**Re: 230488 – Middlebrook Solar Farm and BESS Post Approvals Modification 1 – Aboriginal Cultural Heritage Assessment**

Figure 1. Proposed modifications under Modification 1.

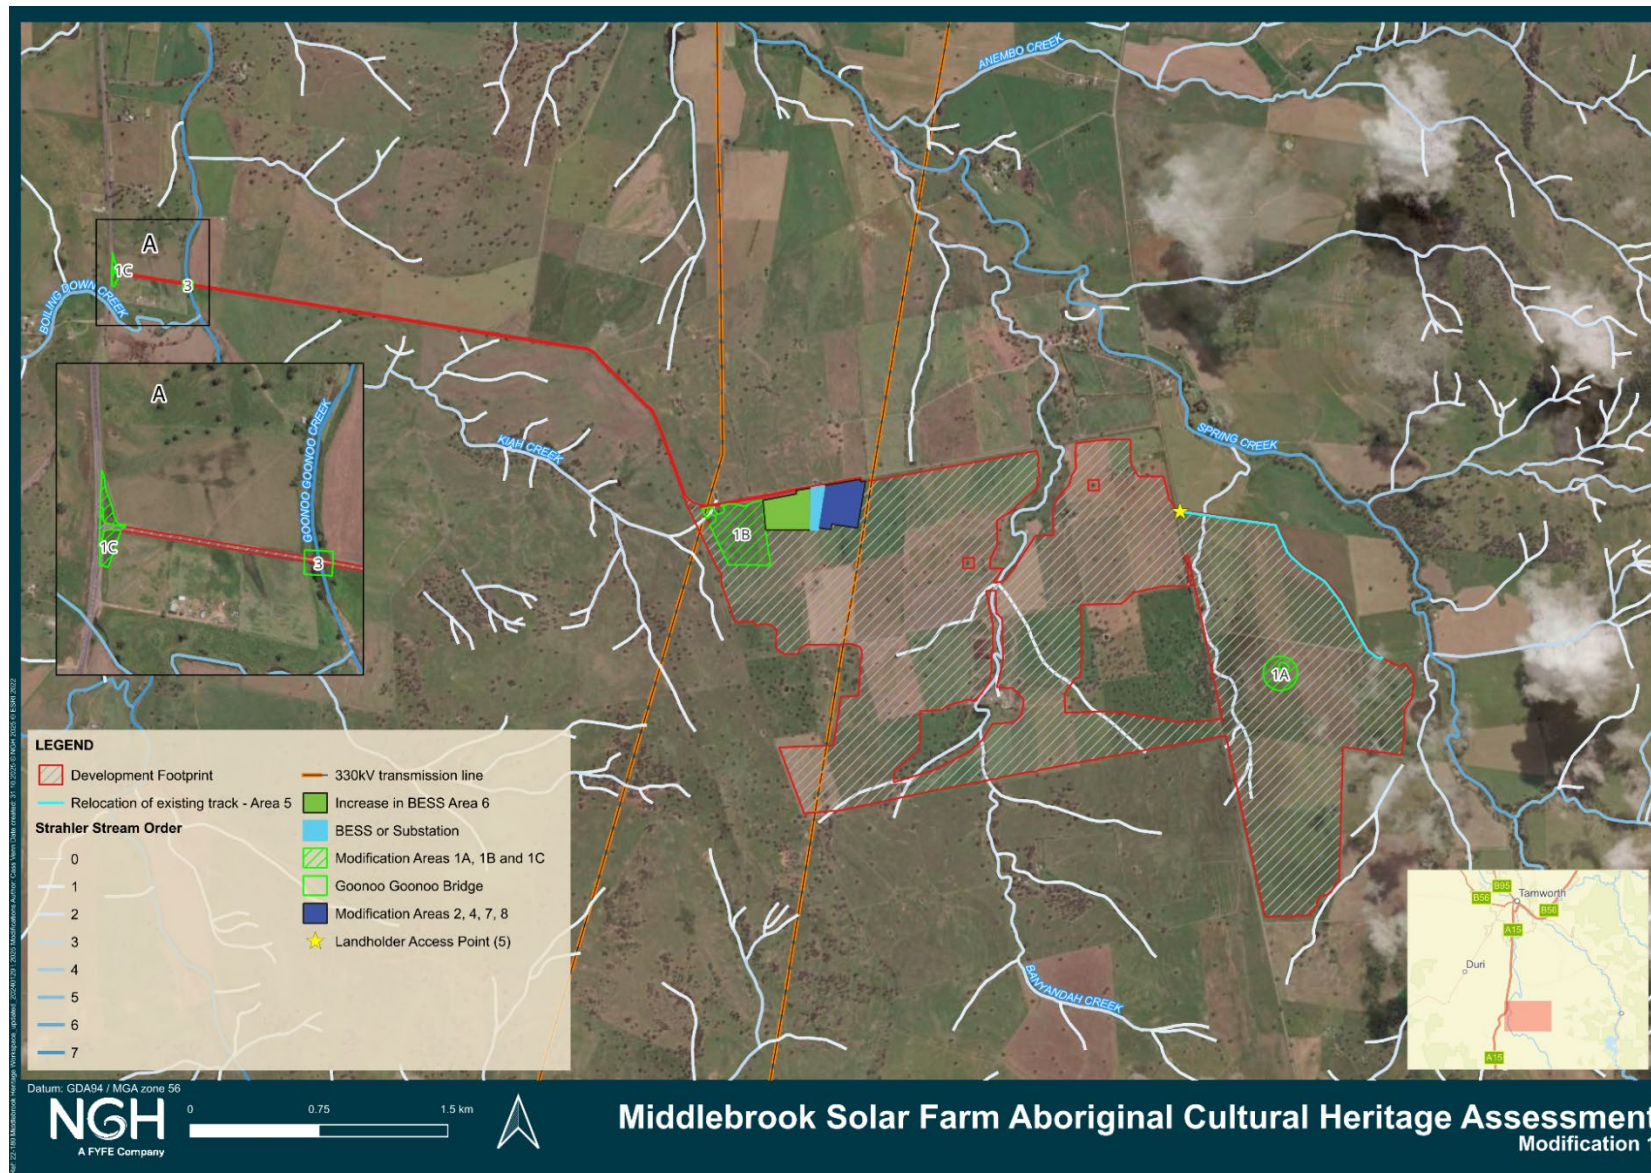
It has since been brought to our attention that the mapping that we provided you with in the previous letter was incorrect. There have been no changes to the nature of the modifications which are listed below:

Although there have been some slight changes to the layout of the modifications represented in the mapping (Figure 1) the modifications remain within the area that was previously surveyed in 2020. The modifications listed above have not changed with the exception of the addition of Area 8 which will be located within the footprint of the substation. The size of the BESS area (6 on the map) has also increased and an additional area between the BESS and substation has been added to allow for further expansion. The modification area 1B has been reduced slightly to accommodate biodiversity values and area 1C has also been refined slightly to reduce impacts.

Figure 2. Location of AHIMS #29-2-0263 relative to the Development Footprint and proposed modifications.

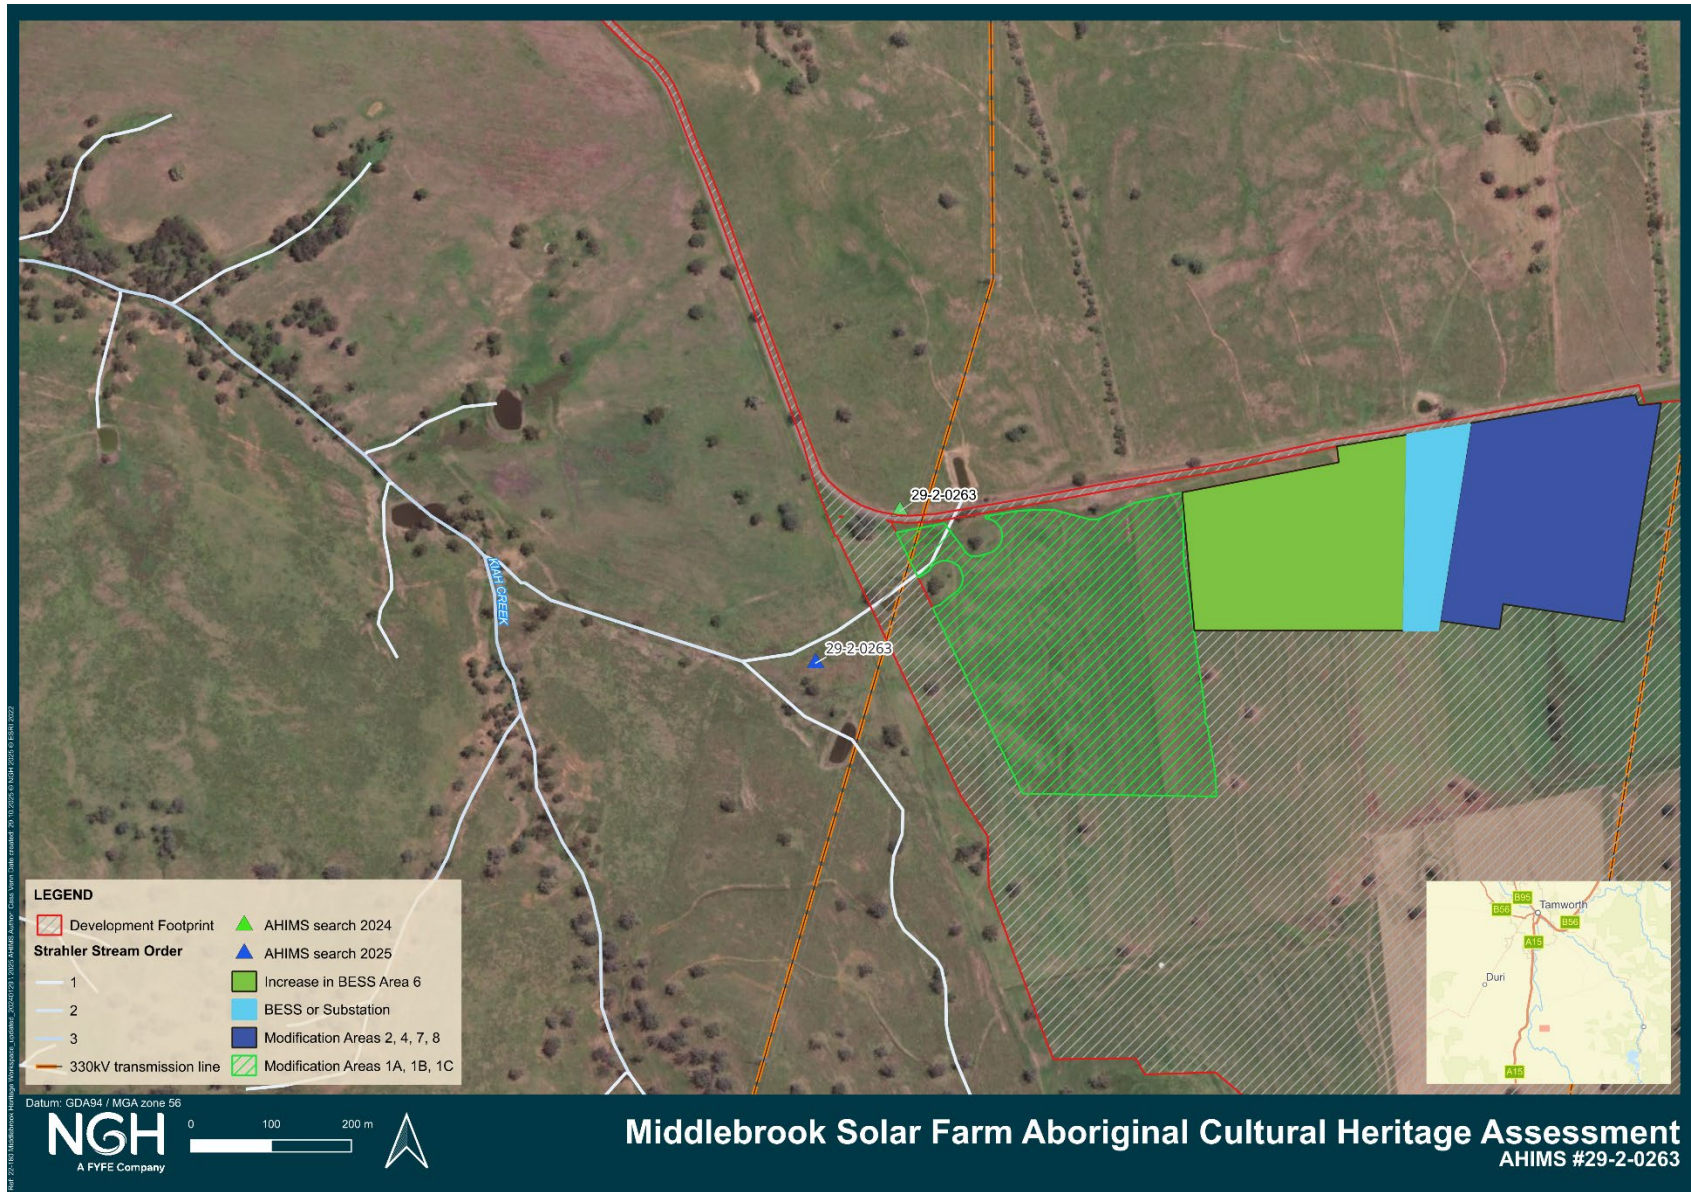
The modifications do not impact any previously recorded sites including the one isolated artefact (AHIMS #29-2-0263) that was identified near the entrance of the solar farm. The previously recorded isolated artefact site was addressed in the previous letter and this site will remain unaffected by the changes (see Figure 2).
